**RE: Crows Nest Over Station Development Site B (SSD-614000212)
Response to Submissions and Additional Information**

This statement summarises Stantec's response to the submissions.

Figure 1: B99 design vehicle waiting to enter car lift

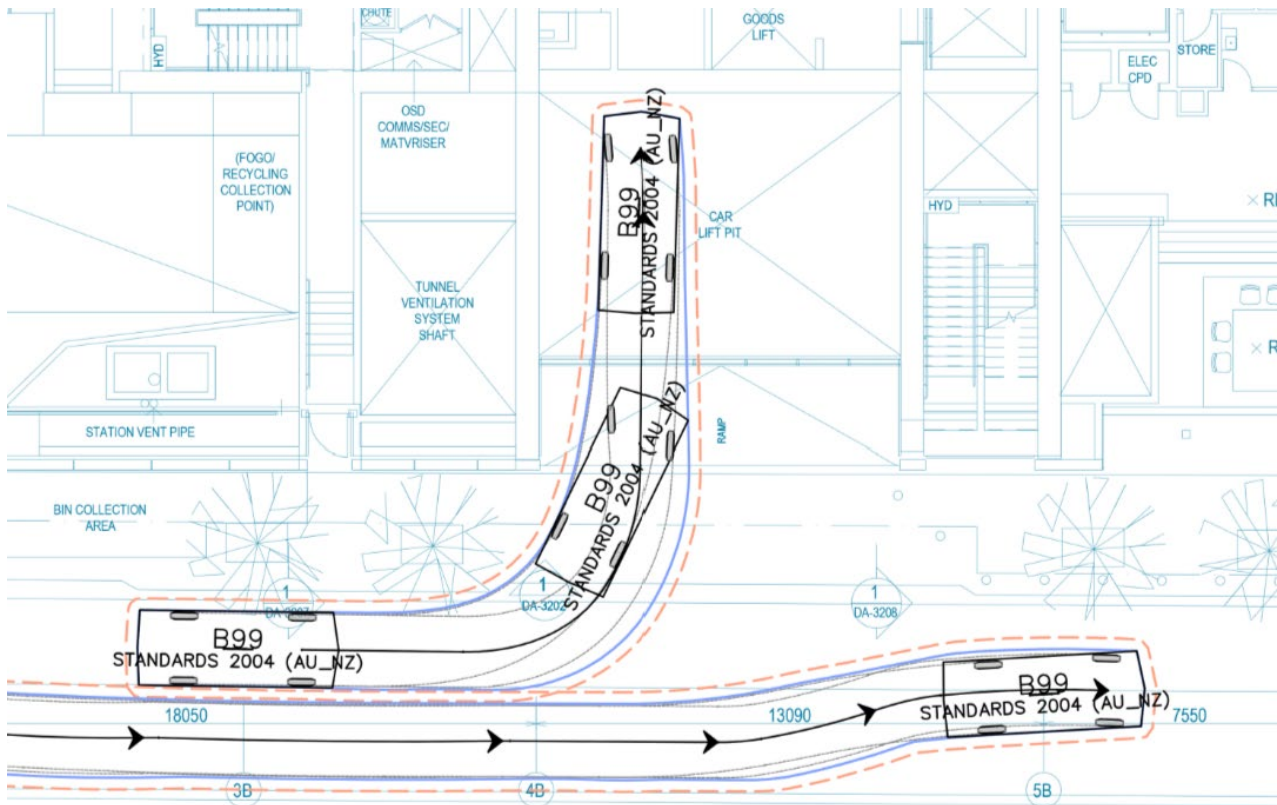
The applicant needs to provide more details on how they would plan to manage a situation where the leftmost car lift has a car coming out at the same time a car is driving into the driveway which would result in cars blocking each other.

As shown in Drawing DA-2210 revision A, prepared by Woods Bagot and included in Appendix A, the car lift pit has been constructed as part of the Crows Nest Metro Station works. The entrance to the car lift pit is setback from the property boundary by approximately 4.0 metres, which is insufficient to store a B99 design vehicle wholly within the site. As shown in Figure 1, if a B99 design vehicle were to wait in front of the car lift, almost the entire width between the car lift entry and Clarke Lane will be required, providing no opportunity for a car exiting the southern car lift to pass the waiting vehicle.

As such, to avoid conflict at the car lift entry and obstruct pedestrian flow along the Clarke Lane frontage, cars will need to wait along Clarke Lane and give way to exiting vehicles. As per the queuing analysis included in Section 4.7 of the TAIA (which has been amended to reflect the updated traffic generation numbers), the 98th percentile queue length during the afternoon peak will be two vehicles, whilst the 93rd percentile queue length will be one vehicle. As this queue length also includes the vehicles in the system, this means that the likelihood of vehicles queuing to enter the site will be very low, if both car lifts are operational. However, as per the Car Parking Strategy and Management Plan, if only one car lift is available, the 98th percentile queue will increase to four vehicles, which means that there will be two vehicles queuing to use the car lifts. In the event that a vehicle is required to wait and give-way to an exiting vehicle, it is noted that the kerbside restriction along the eastern side of Clarke Lane, directly adjacent to the driveway into the car lift, is "No Parking". Vehicles are permitted to stop in "No Parking" zones for up to two minutes.

The swept path assessment included in Figure 1 shows that a B99 design vehicle will be able to travel around another B99 design vehicle stopped kerbside, waiting to enter the car lift.

To manage the conflict, flashing lights and appropriate signage can be installed within the property boundary to alert approaching vehicles along Clarke Lane that there is a vehicle exiting the car lift. This can be detailed during future submissions post SSDA approval.
